TRANSMITTAL LETTER FOR THE RESPONSE TO NEW JERSEY DEPARTMENT OF
ENVIRONMENTAL PROTECTION COMMENTS ON FOCUSED INVESTIGATION AND
REMEDIAL ACTION WORK PLAN FOR BUILDING 556 NWS EARLE NJ

Subject: Response to NJDEP Comments
Focused Investigation and Remedial Action Work Plan for Building 566
Naval Weapons Station Earl, Colts Neck, New Jersey

Brown & Root Environmental

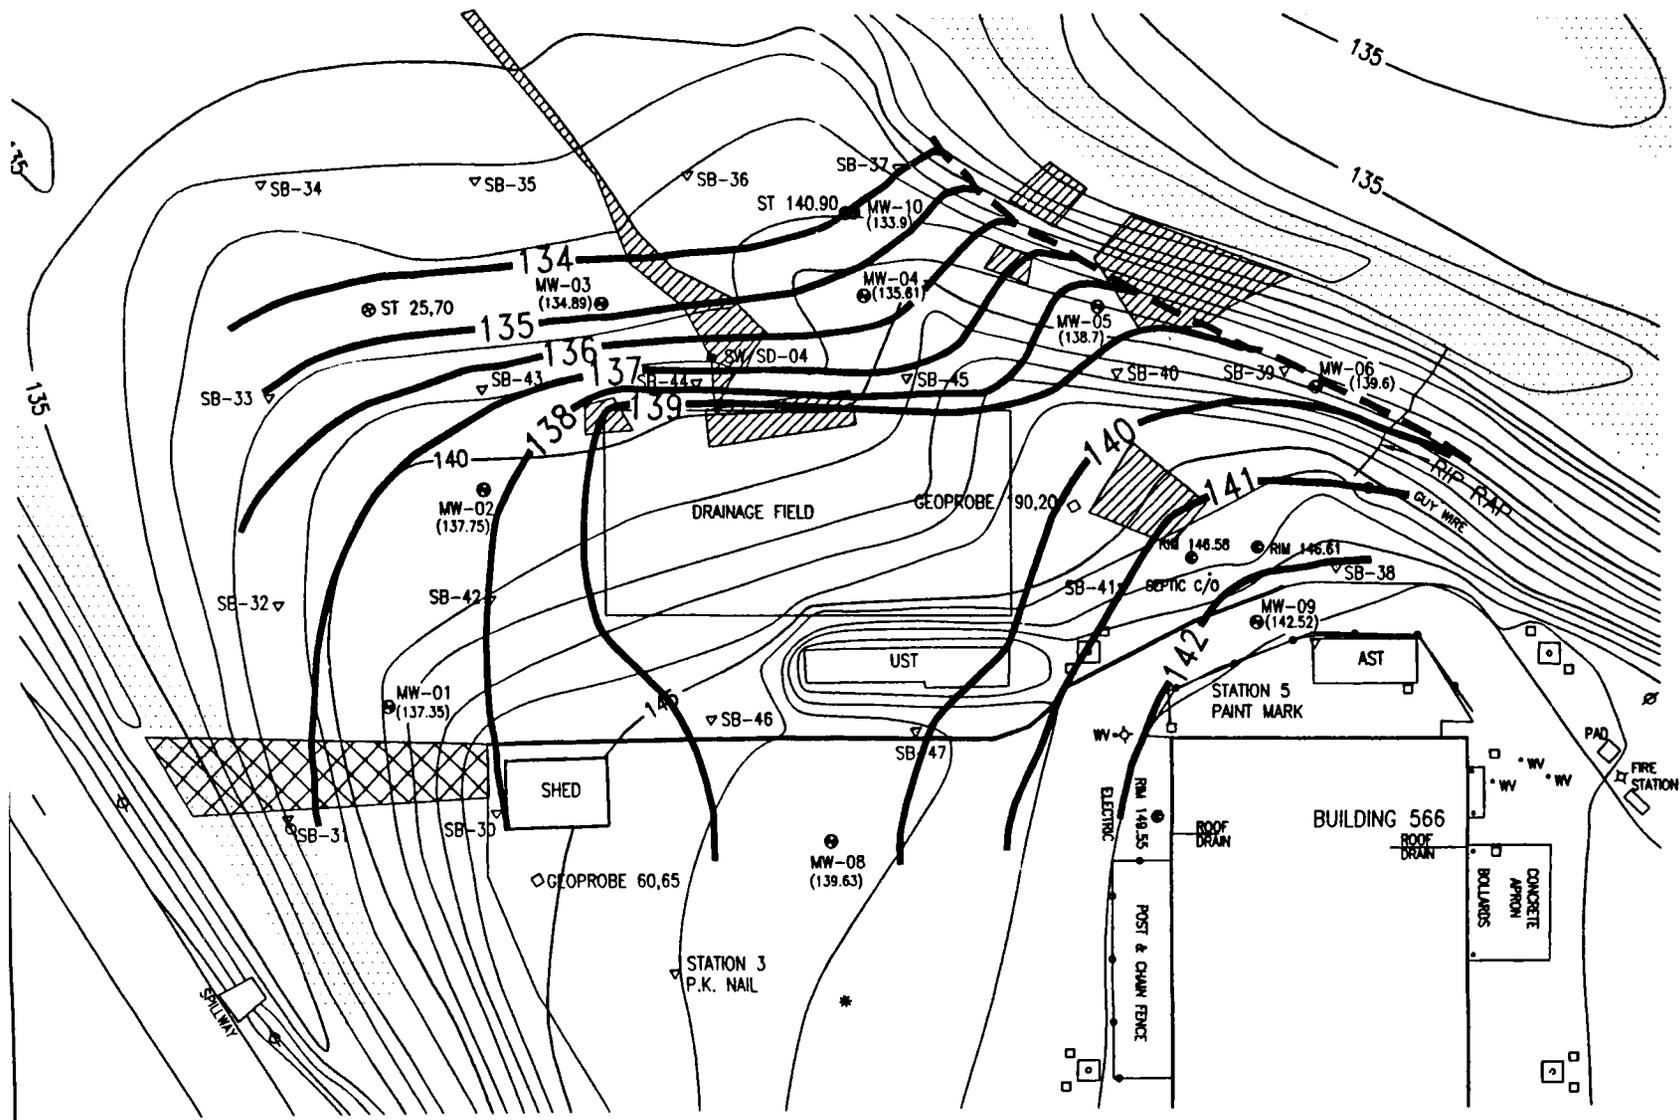
Comment 1: *Section 2.1, Results of Phase I RI, page 2-3: In the first paragraph on this page the contractor states, "The extent of the shallow ground water contamination is limited both horizontally and vertically by the silt-clay." This statement is incorrect. The silt-clay unit only prevents the contamination from migrating vertically, there is no horizontal component to prevent contaminant migration.*

It is correct that the silt-clay lithologic unit can only directly limit the vertical extent of shallow groundwater contamination. However, the presence of the silt-clay lithologic unit indirectly helps to limit the horizontal extent of shallow groundwater contamination by limiting the downgradient extent of the shallow aquifer.

The silt-clay lithologic unit acts as the confining layer for the bottom of the shallow aquifer. The land surface and the silt-clay lithologic unit both generally slope in a radial direction away from the site, in the same general direction of inferred groundwater flow. The top of the silt-clay lithologic unit slopes at a lesser gradient than the ground surface. The net effect of this is a gradual thinning of the shallow aquifer to the point where it is of negligible thickness. The groundwater either intersects the ground surface where it is discharged through seep areas, or is lost through the soil layer by evapotranspiration. These are the circumstances by which the horizontal extent of shallow groundwater contamination is limited. This hydrogeologic model is most clearly demonstrated by the geologic maps and cross-sections of the Phase I Remedial Investigation (RI) Report for Building 566 (Brown & Root Environmental, October, 1996). Copies of these figures are included with this letter in Attachment A. Refer also to the response to NJDEP's Comment 3 below.

SOIL AND GROUNDWATER RESULTS SUMMARY FIGURES FROM THE PHASE I RI REPORT

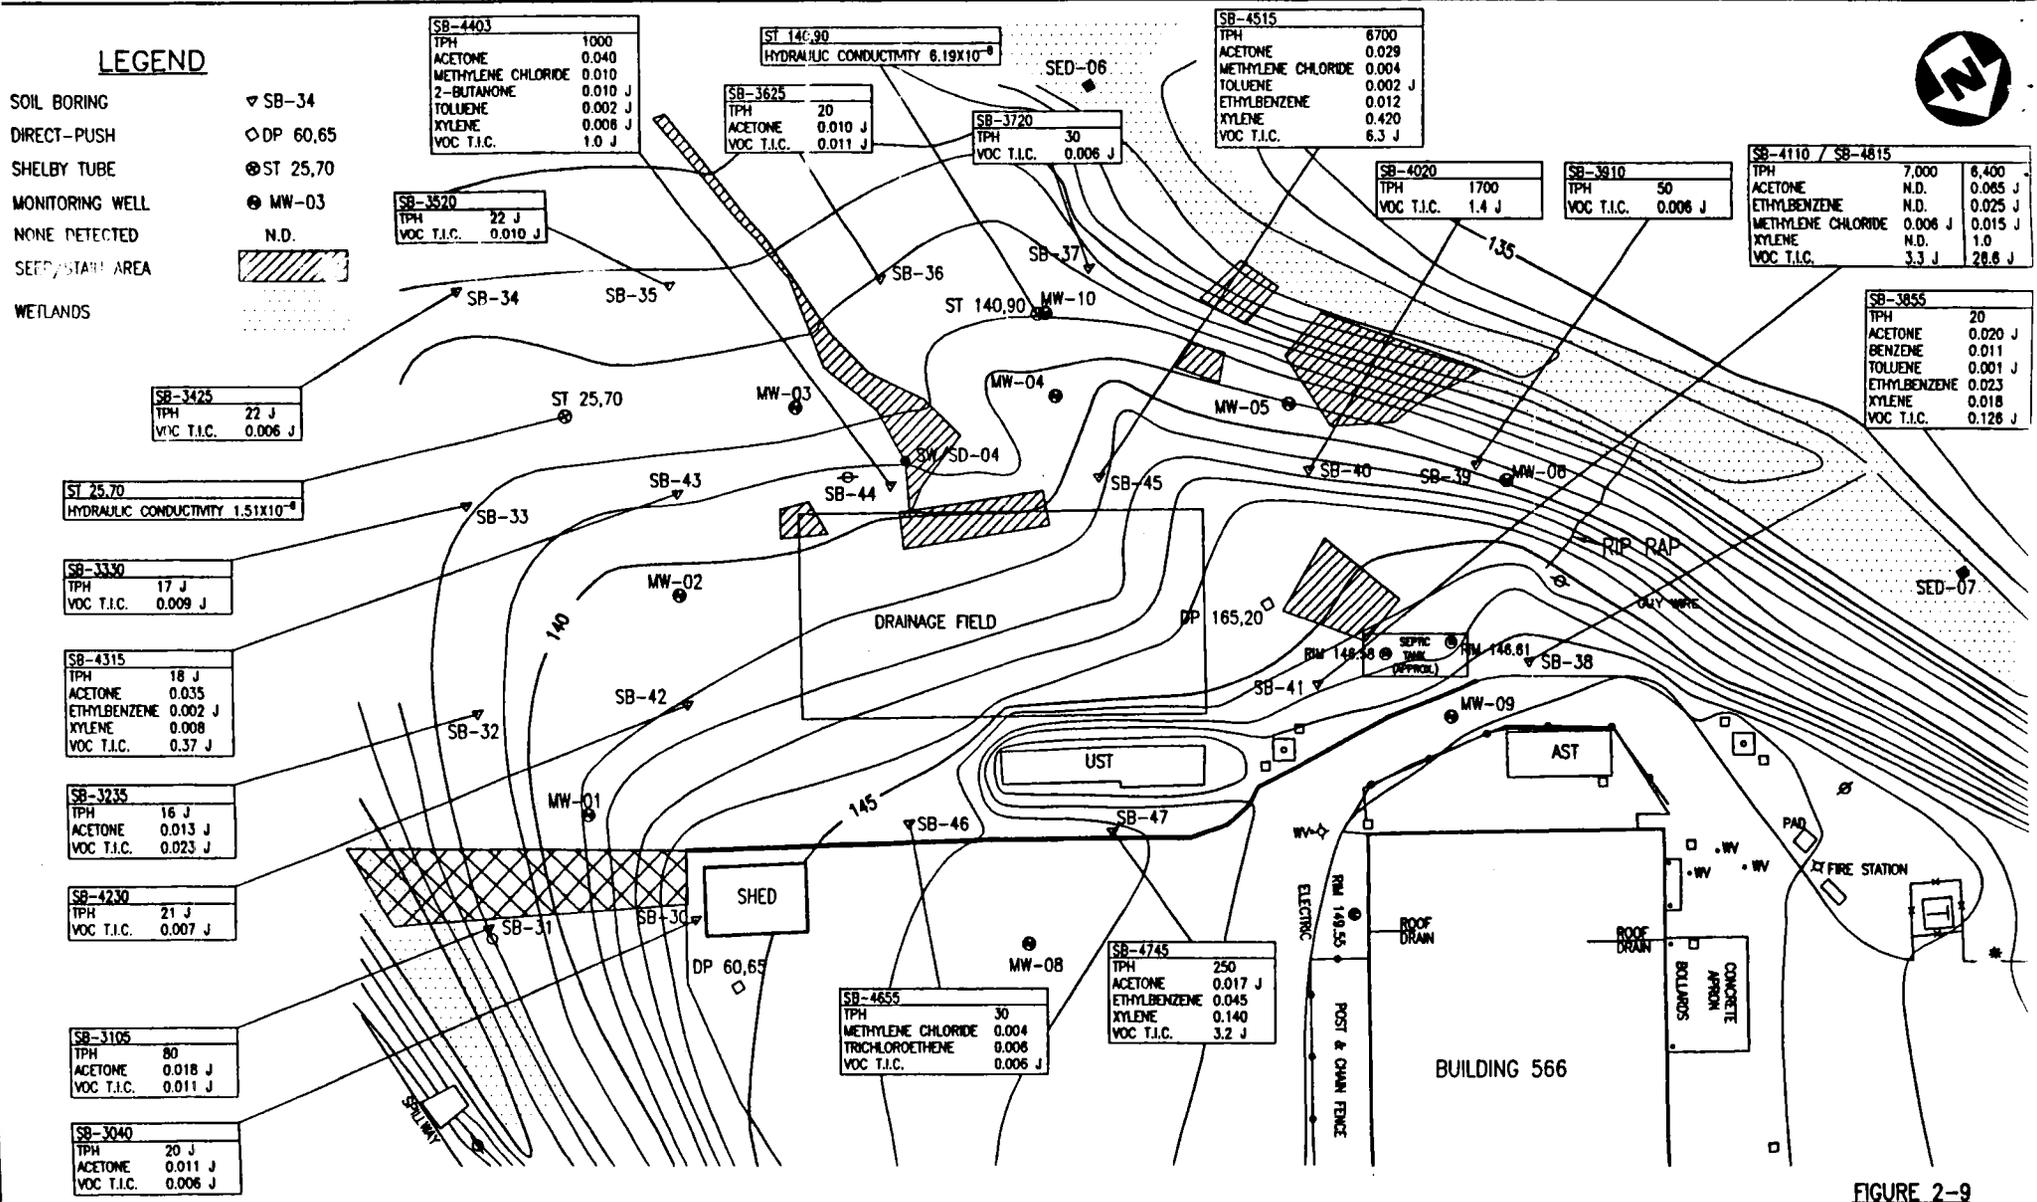
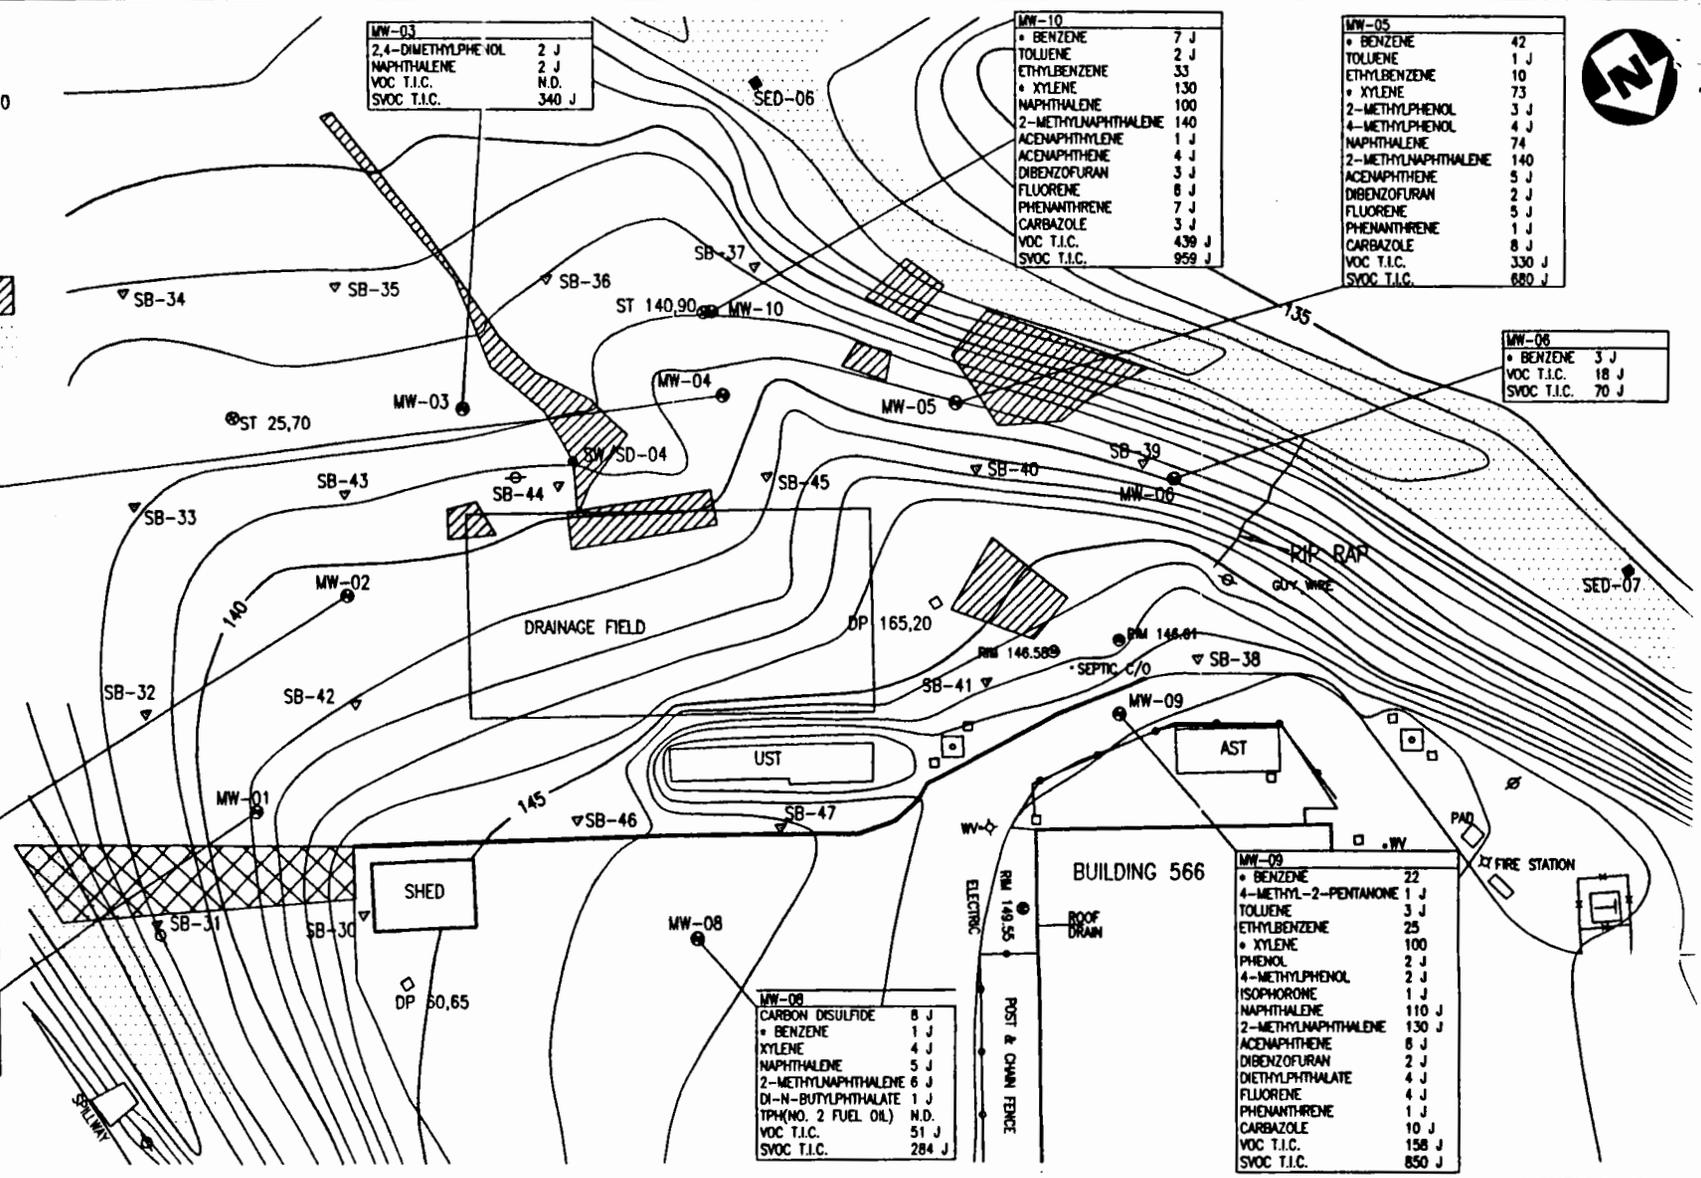
Comment 3: *Section 3.0: The downgradient line of compliance wells is not complete, as the horizontal extent of the plume has not been fully delineated. Additional monitoring wells should be located adjacent to the wetlands.*

B&R Environmental assumes that this comment relates to the wetlands located directly to the east and northeast of the drainage field. Monitoring wells were placed directly east, south, west, and north of the drainage field. Additional monitoring wells were not placed adjacent to the wetlands in this area for the following reasons:

- Although this area is downgradient from portions of the drainage field, only trace levels of petroleum-related compounds were observed in soil and groundwater samples obtained here during the Phase I RI. In particular, Phase I RI monitoring well MW-01, and subsurface soil samples SB-31, SB-32, SB-33, SB-34, and SB-42 were located within this area. No volatile organics were positively detected in the soil or groundwater samples from this area. No semivolatiles were detected in the groundwater samples, and the maximum level of total petroleum hydrocarbons detected in the soil samples was 80 mg/kg. Refer to Attachment B for copies of the soil and groundwater sample summary figures from the Phase I RI Report.

- Based on mapped elevations of the top of the silt-clay lithologic unit and the top of the shallow groundwater surface, the wetlands represent the eastern-most extent of the shallow aquifer in this area. Therefore, this would represent the maximum possible extent of shallow groundwater contaminant migration in this area. No petroleum stained seeps or soils indicating contaminant migration to this point were observed.
